**SITING BOARD STAFF'S SECOND REQUEST FOR
INFORMATION TO HORUS KENTUCKY 1 LLC
(with Confidential Information in Highlight)**

Horus Kentucky 1 LLC provides the following responses to the Siting Board Staff's Second Request for Information. The following exhibits are attached hereto as a part of this response:

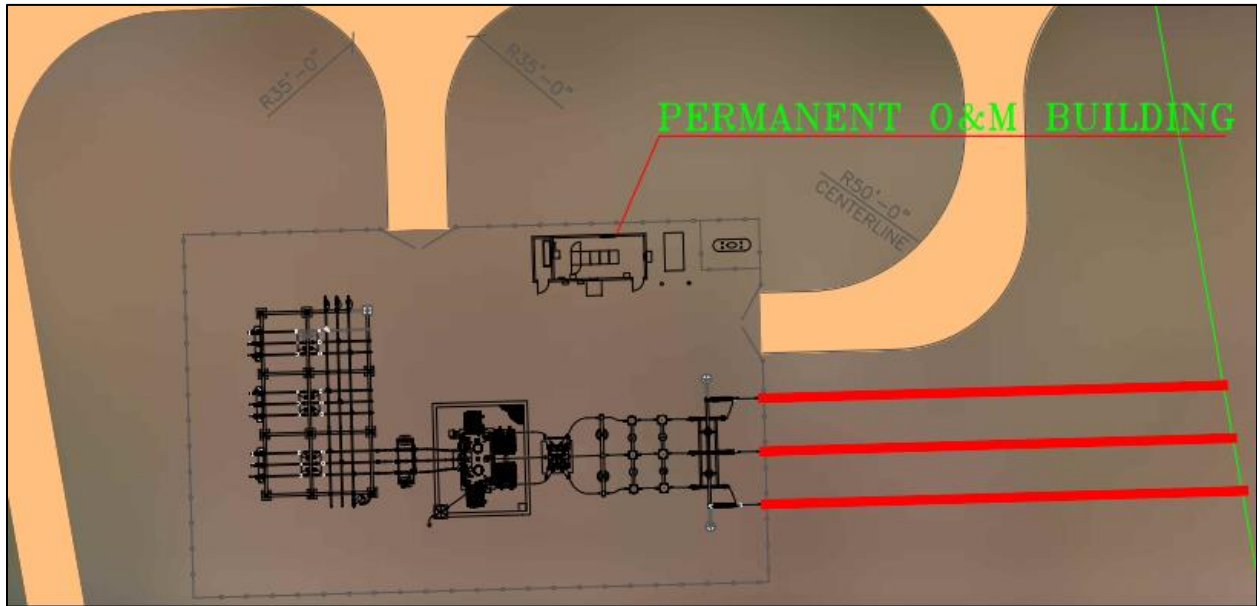
6. Refer to Horus Kentucky 1's response to Staff's First Request Item 27 (f)

a. Confirm that the risk avoidance areas are related to geological features or conditions on the Project site: [Confirmed, the risk avoidance areas were determined through the Preliminary Karst Assessment \(originally provided in Appendix K-Additional Due Diligence Reports of the Application\). The following aerial shows the avoidance areas \(circled in red outline\), which were then incorporated into the **Revised Site Plan Layout Map** provided in **Appendix B:**](#)

- b. Confirm that no construction activities will occur within any of the risk avoidance areas: [Confirmed](#).
 - c. Confirm that no Project facilities or infrastructure will be located within any of the risk avoidance areas: [Confirmed](#).

- d. Confirm that land within any of the risk avoidance areas will not be disturbed: [Confirmed](#).
7. Refer to Horus Kentucky 1's response to Staff's First Request Item 27 (g).

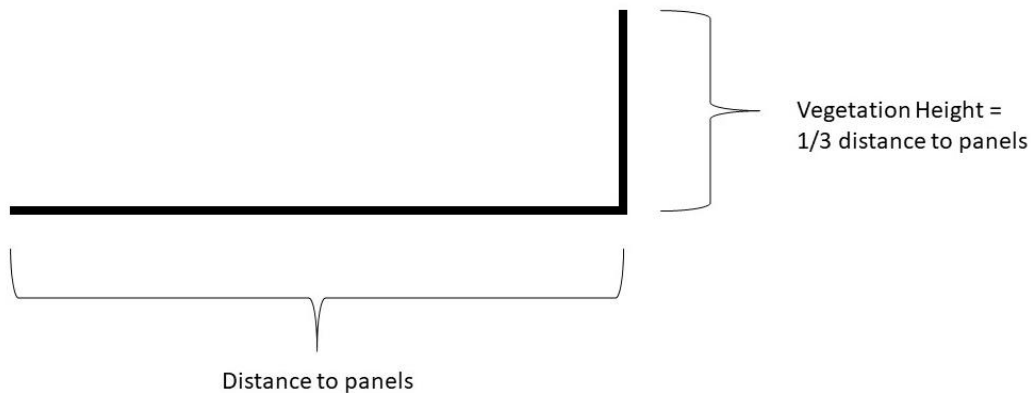
f. If noise receptors exist on Hendricks Road, provide the combined operational sound level for each: The Sound Study was revised to include 2 receptors for residential properties with Hendricks Road addresses in addition to the property at 1666 Tyree Chapel Road. Table 6 was revised to include the combined operational sound level for all 3 of the added receptors.

g. If the residential structures in Tax Parcel #5, #6 and #12 are noise receptors, provide the combined operational sound level for each: The Sound Study was revised to include 2 receptors for residential properties with Hendricks Road addresses in addition to the property at 1666 Tyree Chapel Road. Table 6 was revised to include the combined operational sound level for all 3 of the added receptors.
